Addendum to GSI Typical Details

June 2023

This is an addendum to the Green Stormwater Infrastructure Typical Details Version 2.0. A previous version of this Addendum was released in December 2020. Replacement and pilot details are presented on the following pages in PDF form. Updates have been made to the CAD versions in the .zip file on the [GSI Resource Directory](#).

C-14

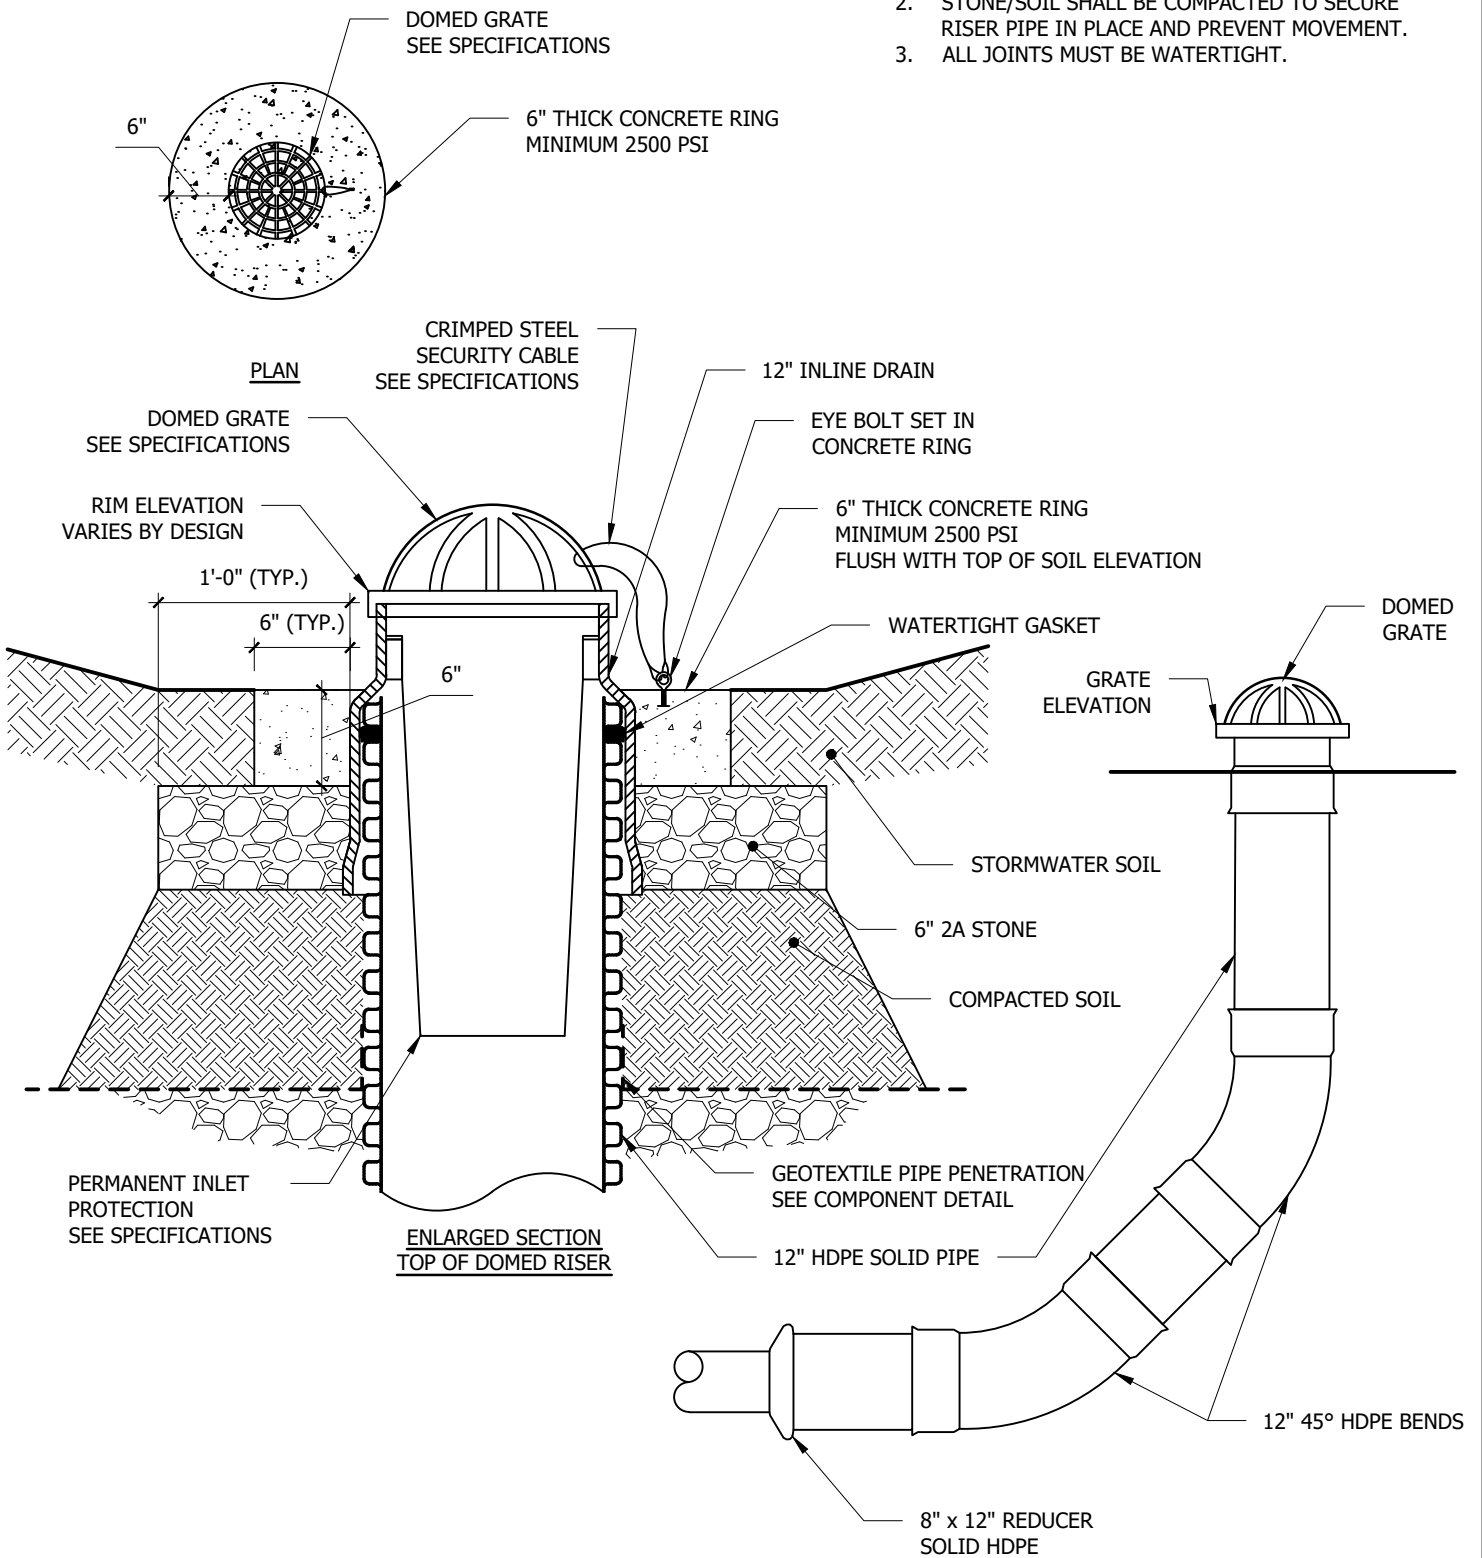
C-14, C-15, and C-16 Domed Risers

Updated in 2022 to remove mulch layer over stormwater soil and call out solid cap at Domed Riser Standpipe sump.

VS.	DATE	INITIALS	REASON
1	09/01/2016		
2	06/01/2018	ANJ	REVISED TO MORE ACCURATELY MATCH SPECIFICATIONS
2	01/27/2022	DJM	REMOVED MULCH LAYER

C-23

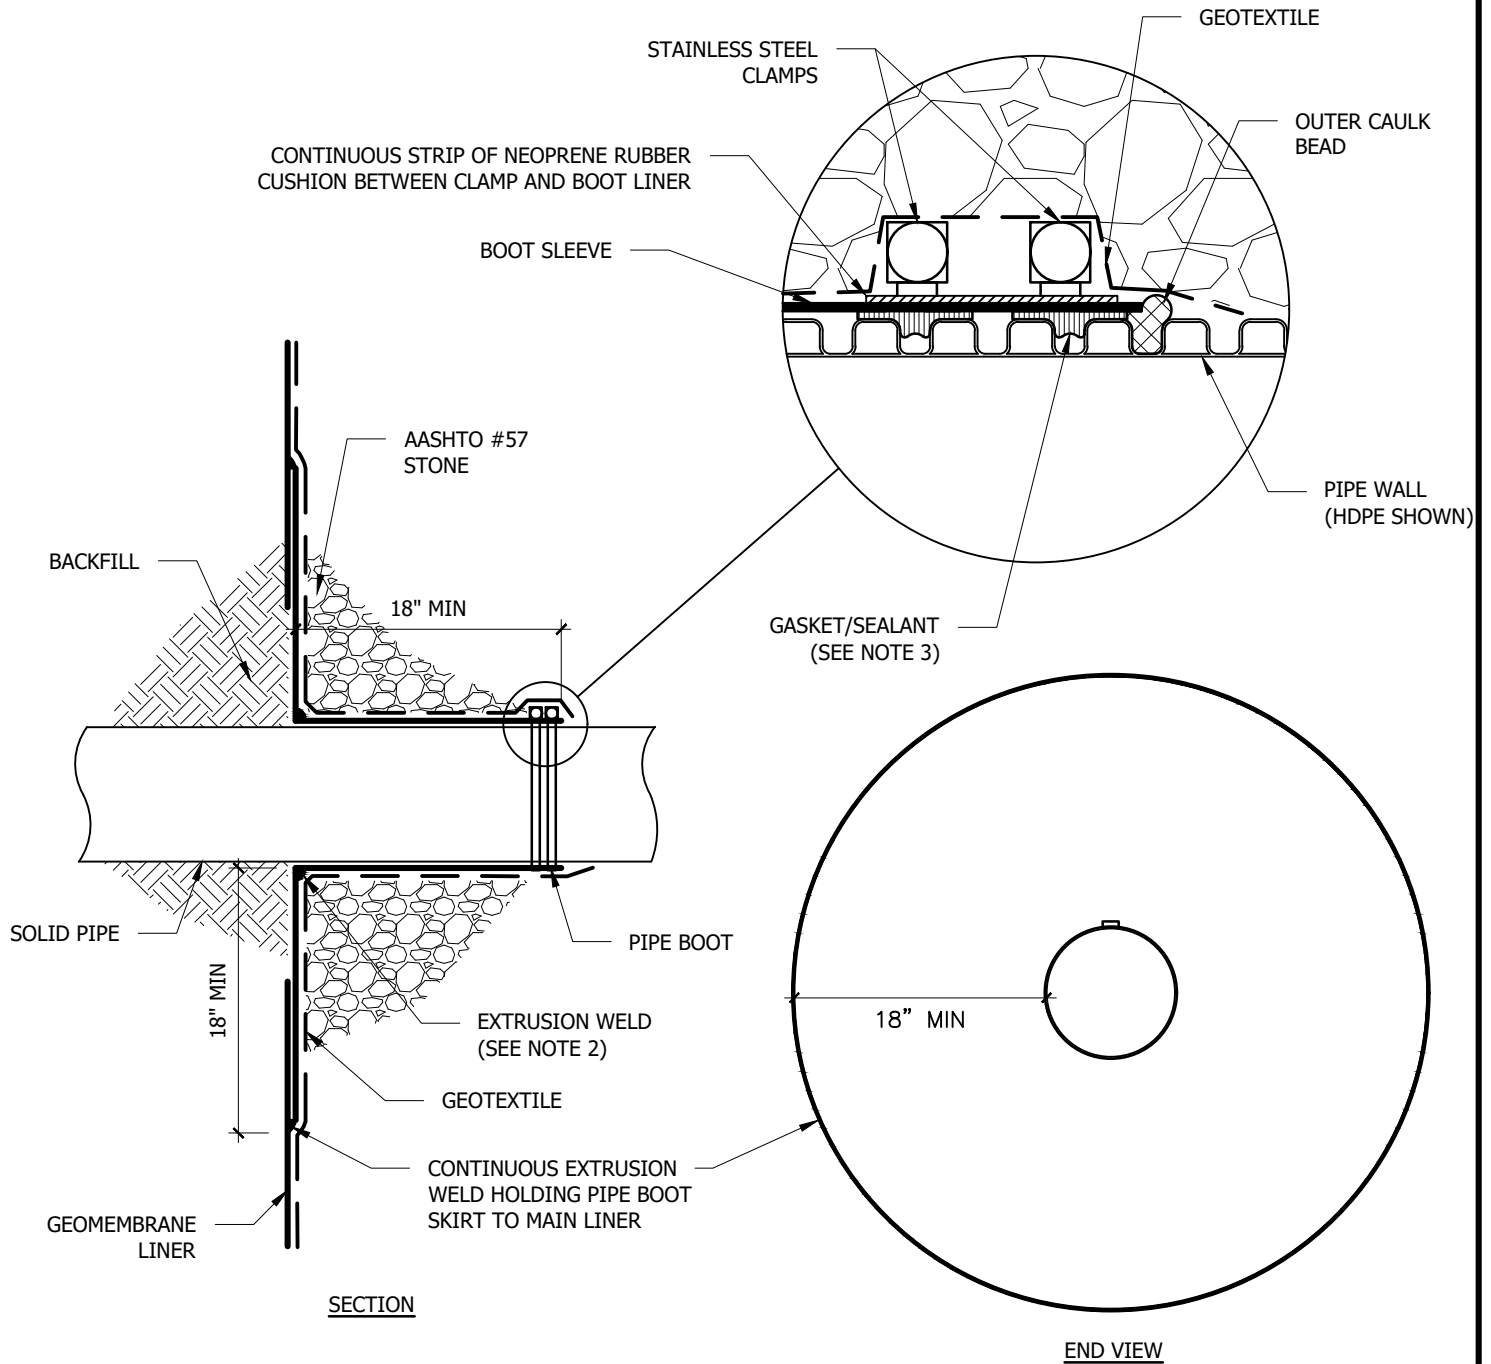
C-23 Geomembrane Pipe Penetration

Update in June 2023 to clarify that solid (not perforated) pipe is used at penetration.

VS.	DATE	INITIALS	REASON
1	06/01/2018	ANJ/DJM	
2	06/30/2023	DJM	CLARIFIED THAT PIPE AT PENETRATION IS SOLID

P-1

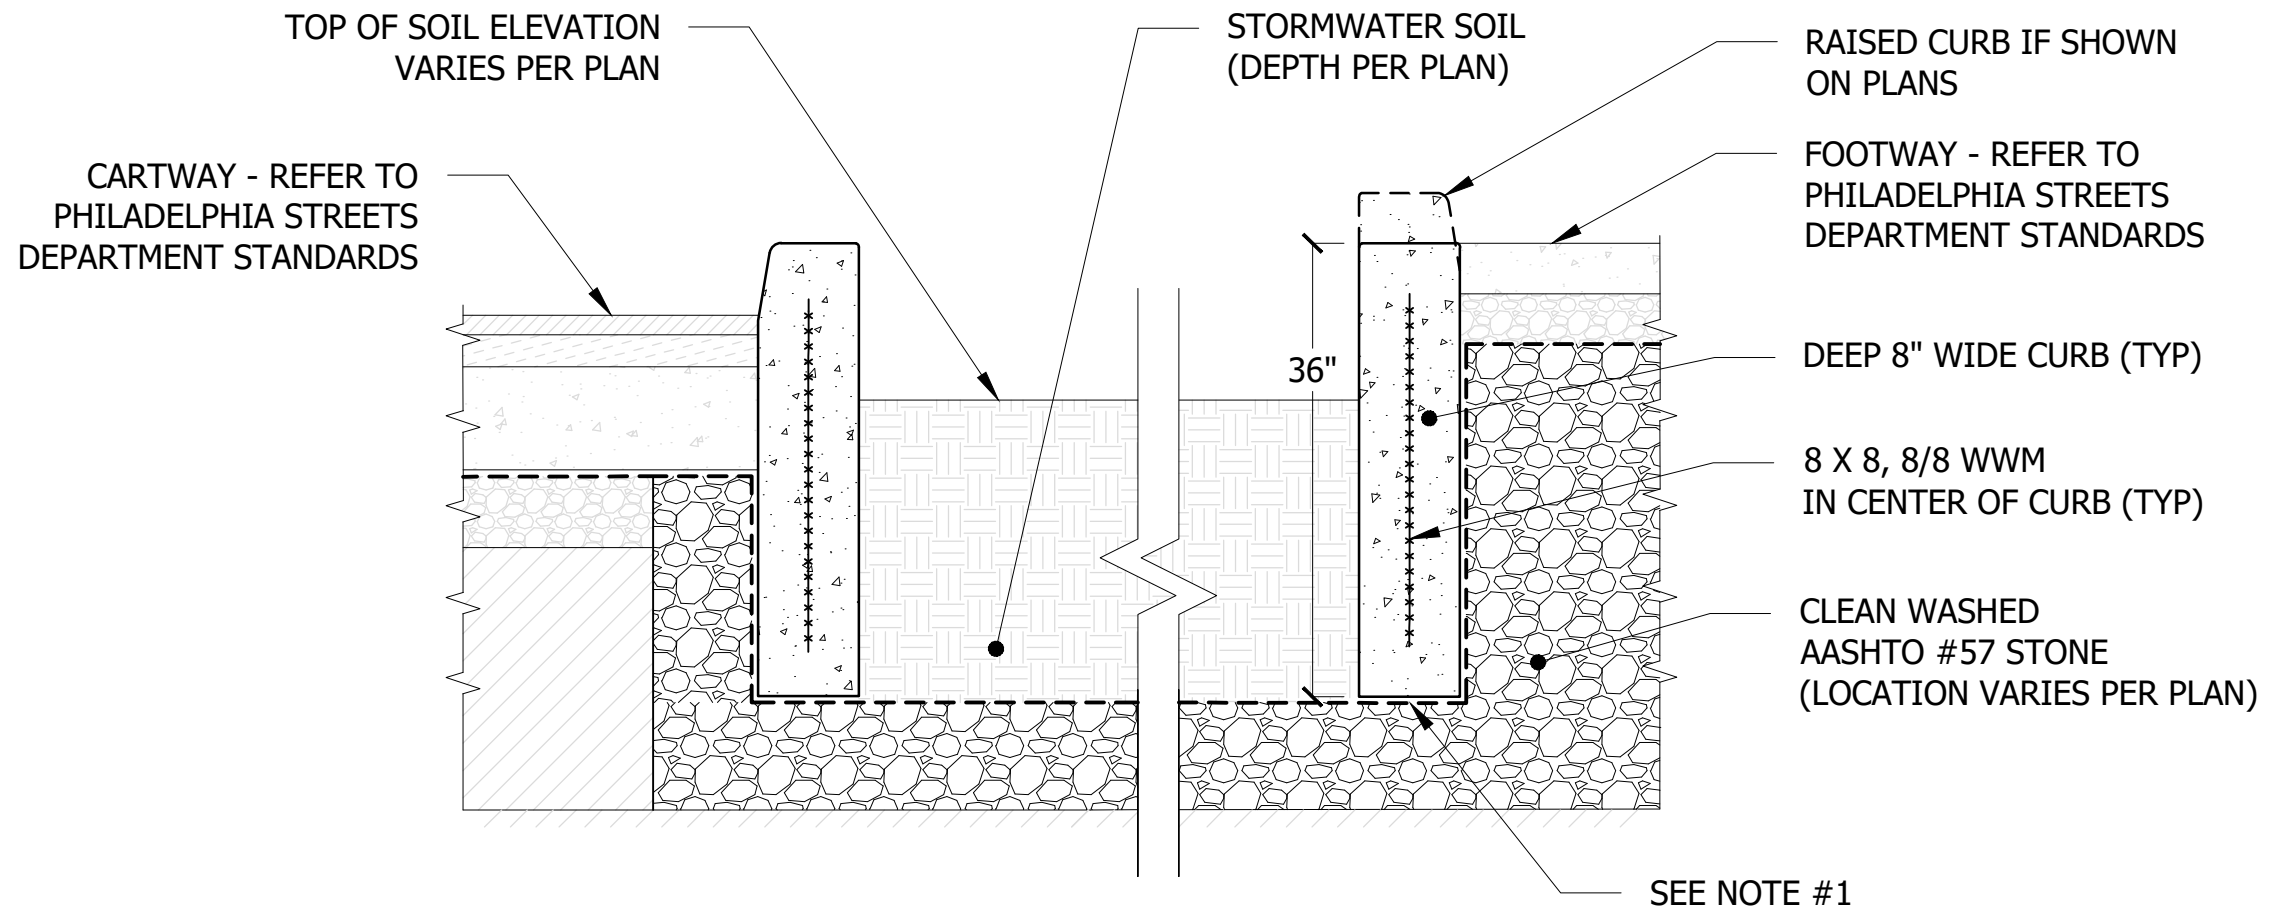
P-1 Bumpout Curb

Developed in 2020 to ensure curb structural stability and allow sufficient stormwater soil depth within bumpouts. Updated version developed in 2022, removing 2A stone support under curb and replacing the curb with support (L-shaped curb) on the cartway side with a deep curb matching the footway side for consistency in bid item and construction methods. Version with 10"x16" concrete curb support may still be used on an individual project basis (request from PWD if needed).

VS.	DATE	INITIALS	REASON
1	12/4/2020	NJP/DJM	
2	03/30/2022	DJM	REMOVED 2A STONE UNDER CURB, MATCHED CARTWAY SIDE DESIGN TO FOOTWAY SIDE

P-2

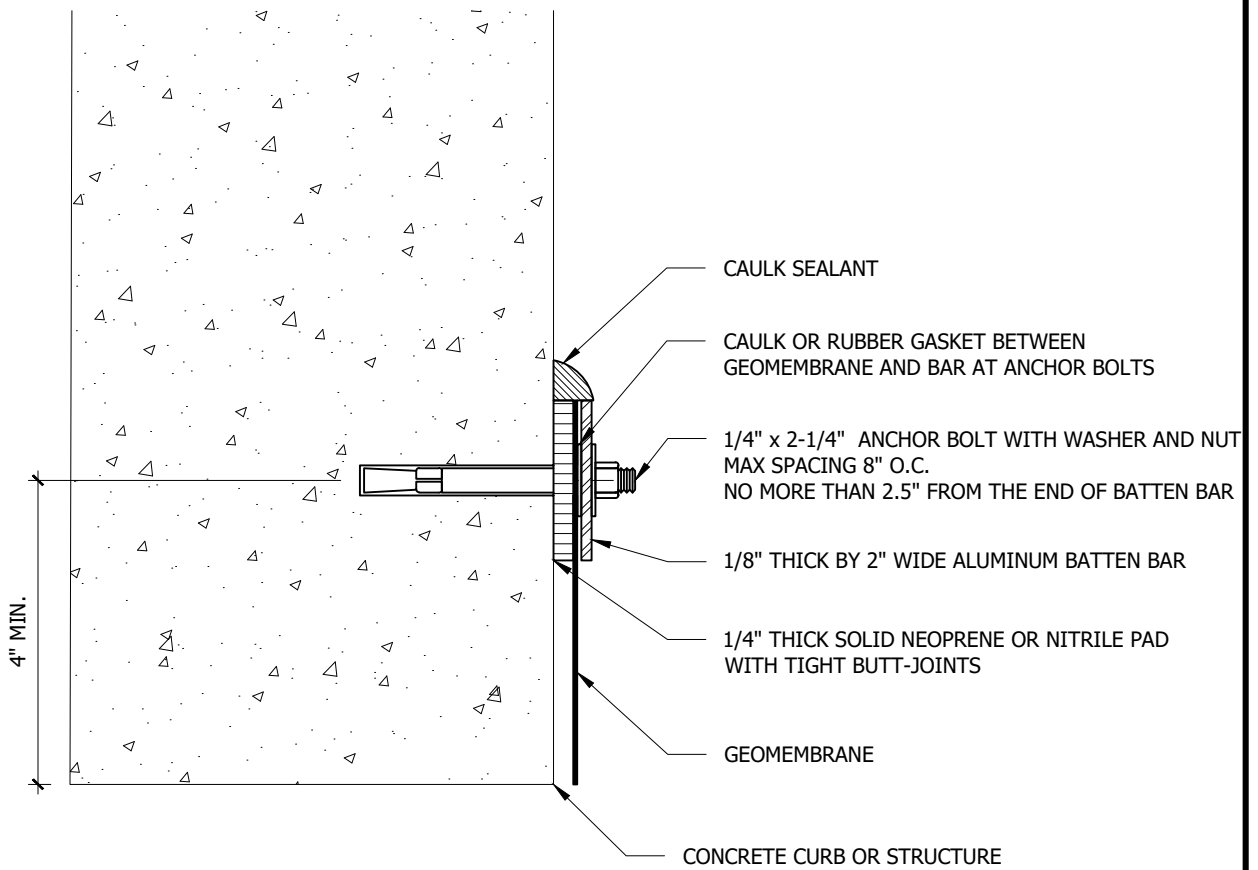
P-2 Batten Bar - Geomembrane Attachment to Concrete

Developed in 2020 for attaching impermeable geomembrane liner to concrete structures.

P-3

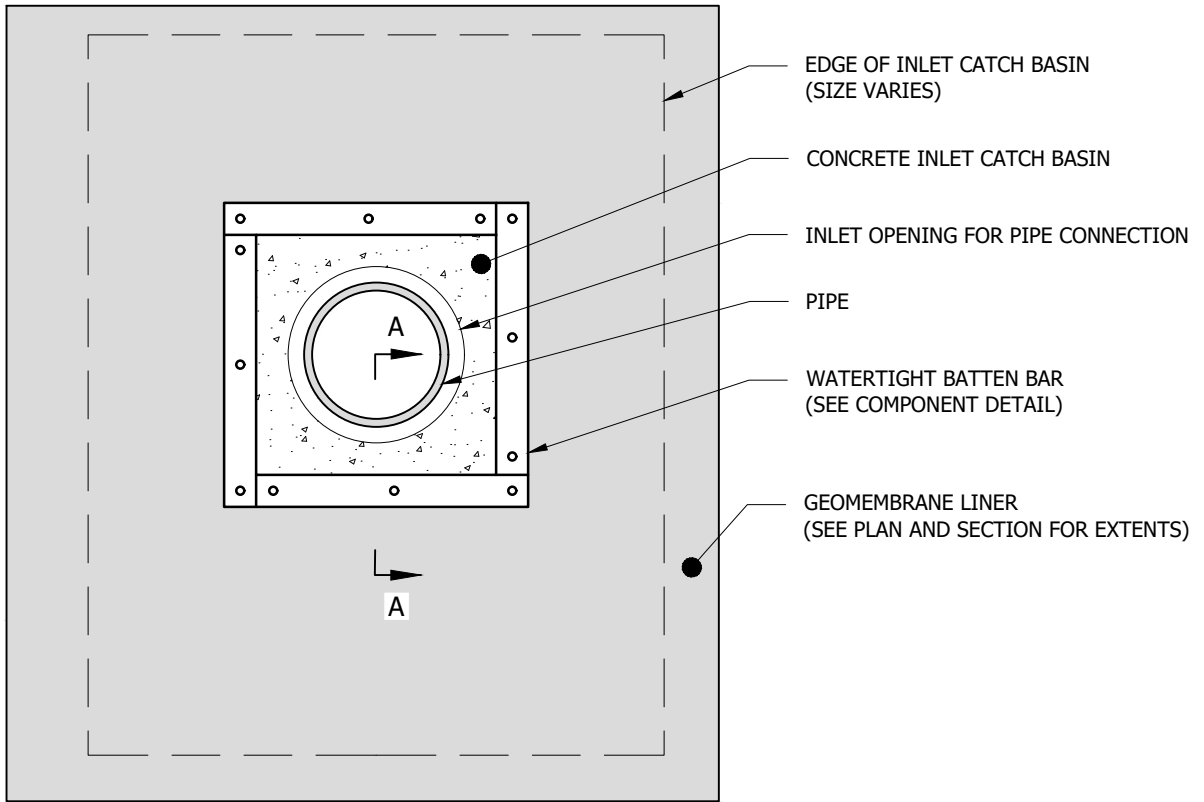
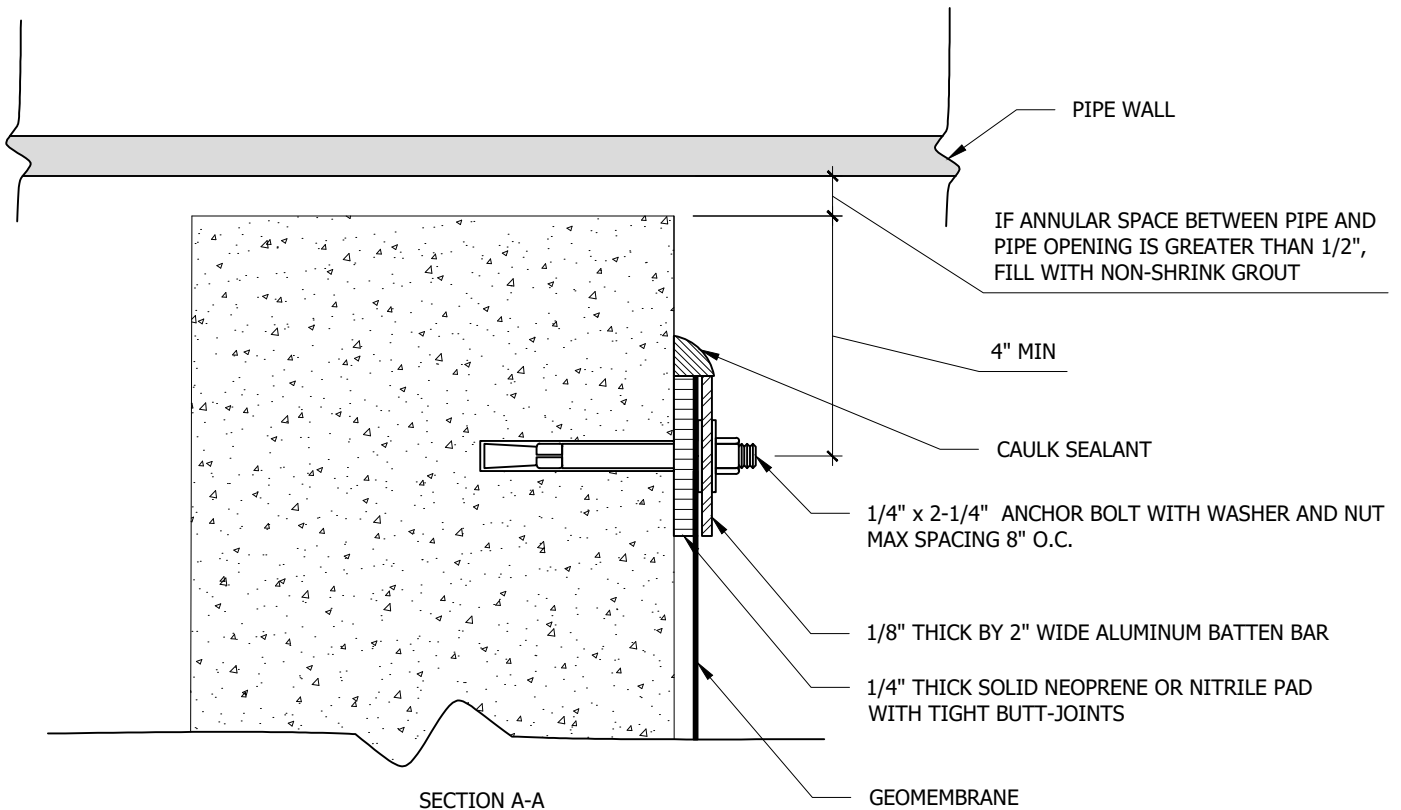
P-3 Alternative Geomembrane Pipe Penetration at Inlet

Developed in 2022 to give contractors the option of using batten bar attachment to concrete inlet catch basin as an alternative to boot seals at geomembrane liner pipe penetrations.

P-4

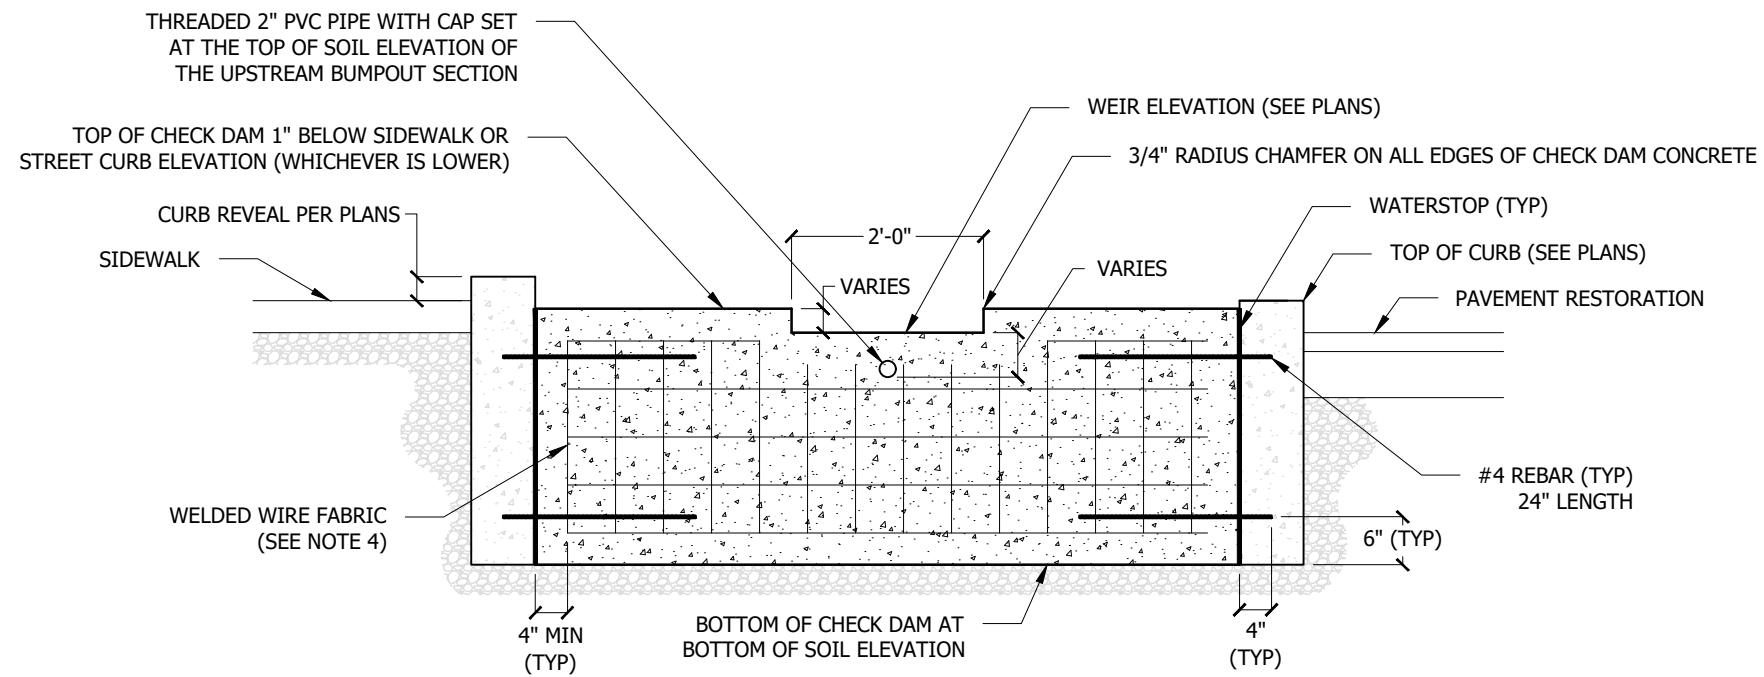
P-4 Check Dam

Developed in 2021 to standardize design of check dams in bumpouts.
